ADDENDUM 1 – JOB 26

TO: All prospective bidders on Project NH-4-002(125)905, Job No. 26 scheduled for the November 13, 2020 bid opening.

PROJECT INFORMATION		
Project:	NHU-4-002(131)906	PCN: 22446
Location:	US 2B (Burdick Expy) – 1 st St SW to Valley Street	
Date:	11/03/2020	Lead Designer: Apex Engineering Group
Bid Opening Date:	11/13/2020	JOB#: 26 Addendum#: 1

PROJECT INFORMATION		
Project:	NH-4-002(125)905	PCN: 22216
Location:	US 2B (Burdick Expy) – 16 th St SW to S Broadway (US 83) & 16 th St SE to 27 th St SE	
Date:	11/03/2020	Lead Designer: Apex Engineering Group
Bid Opening Date:	11/13/2020	JOB#: 26 Addendum#: 1

Revised 11/03/2020	STATE	PROJECT NO.	SECTION NO.	SHEET NO.
	ND	NHU-4-002(131)906	100	4

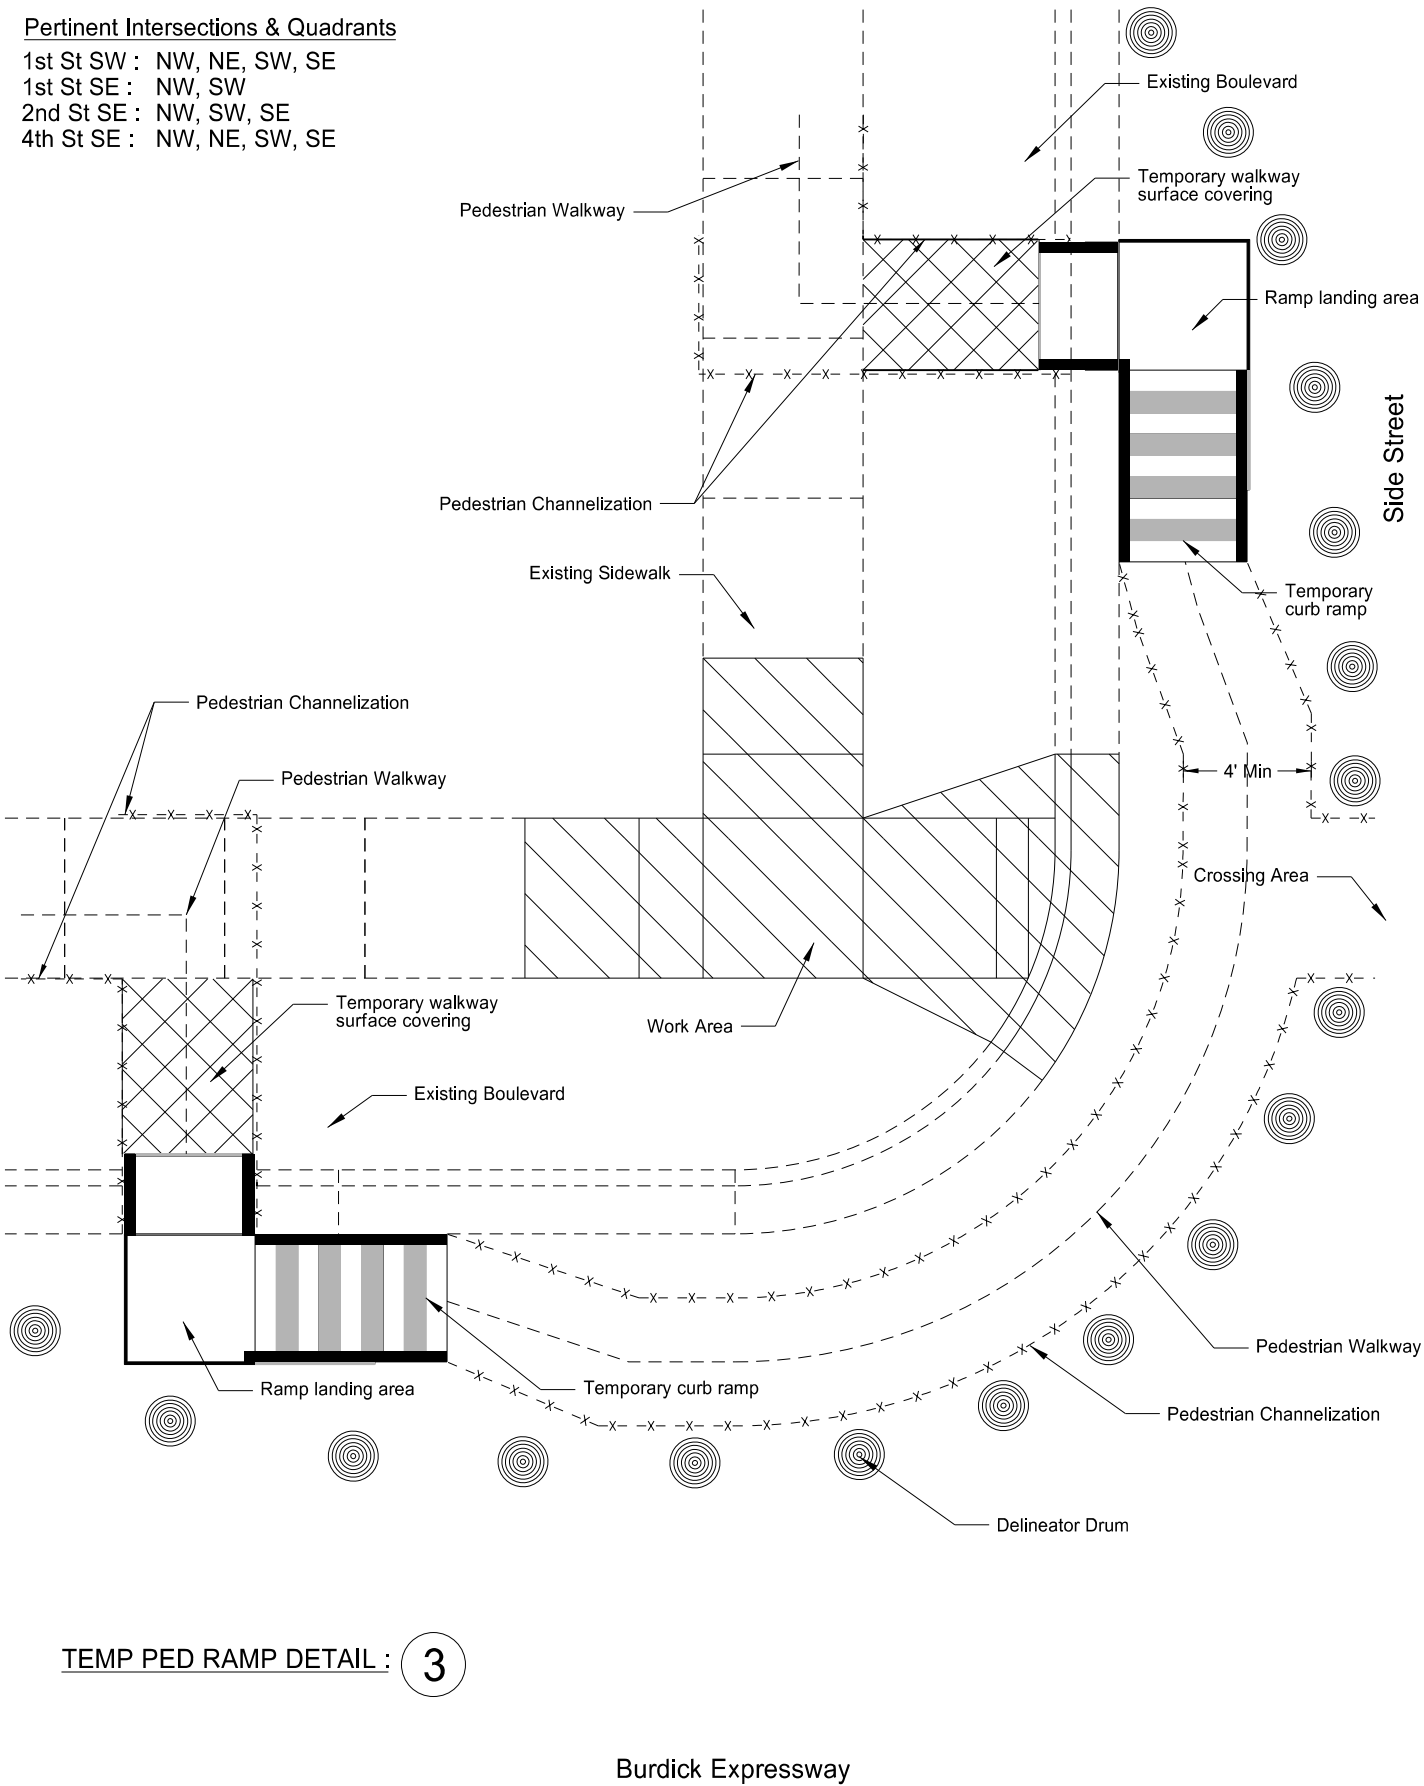
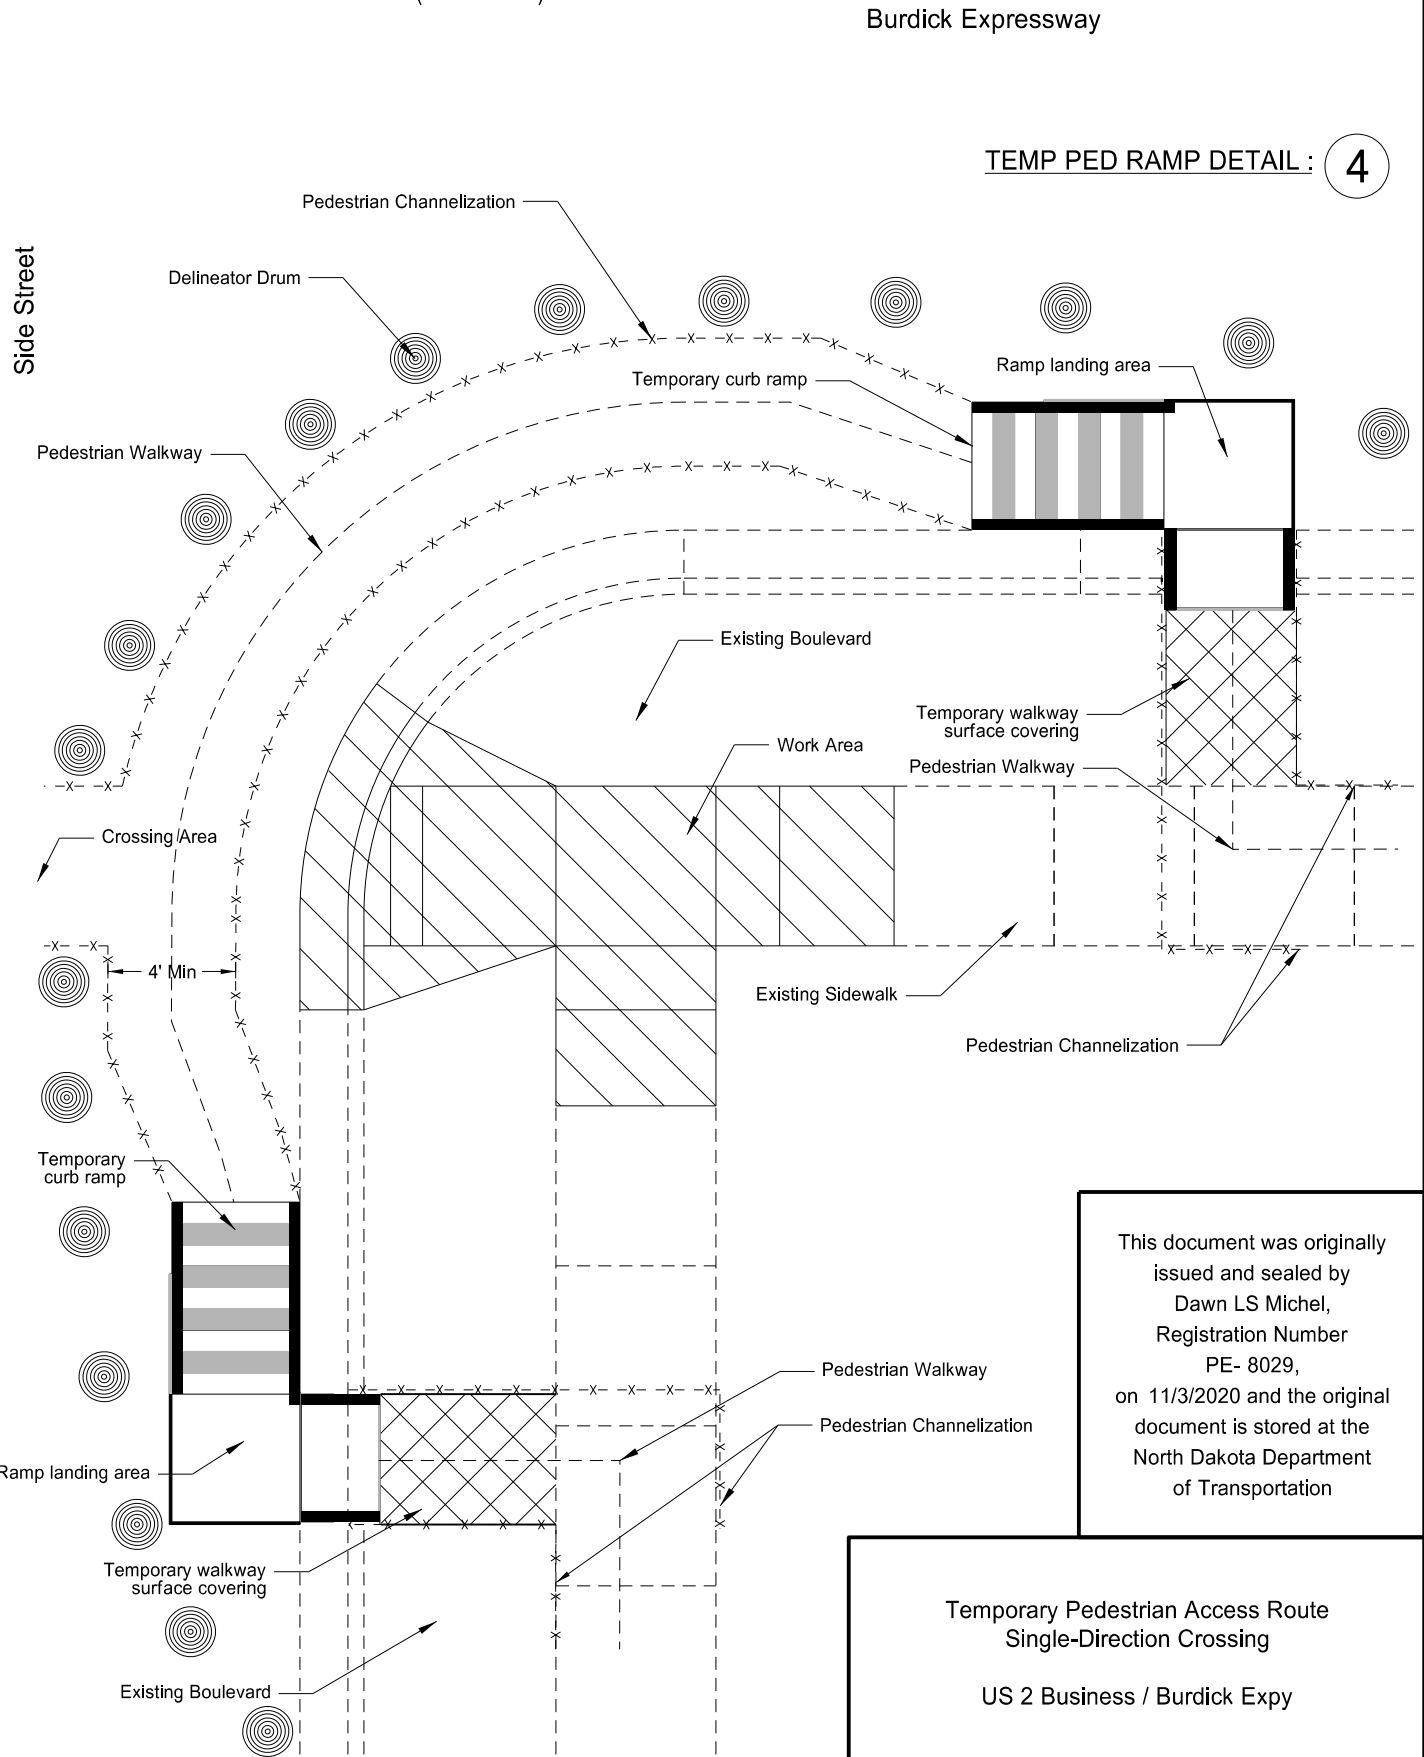
PLAN SHEET CHANGES		
Section	Sheet	Description
6	2	Revised Plan Note 704-P03
6	5	Revised Plan Note 772-P03
6	8	Revised Plan Note 772-P21
8	1	Revised quantities for Flat Sheet for Signs – Type XI and Flat Sheet for Signs – Type IV
100	4	Removed “NE” from the 2 nd St listings in upper left corner
150	14	Removed transformer base from Pushbutton #1 Post
150	15	Removed transformer base from Pushbutton #3/#4 Post and #4/#3 Post; Revised labeling for Pushbutton Post #4/#3 to #7/#8
150	23	Removed transformer base from Pushbutton #5 Post
150	24	Removed transformer base from Pushbutton #3 Post; Removed transformer base from Pushbutton #7/#8 Post
150	32	Added transformer base to signal poles
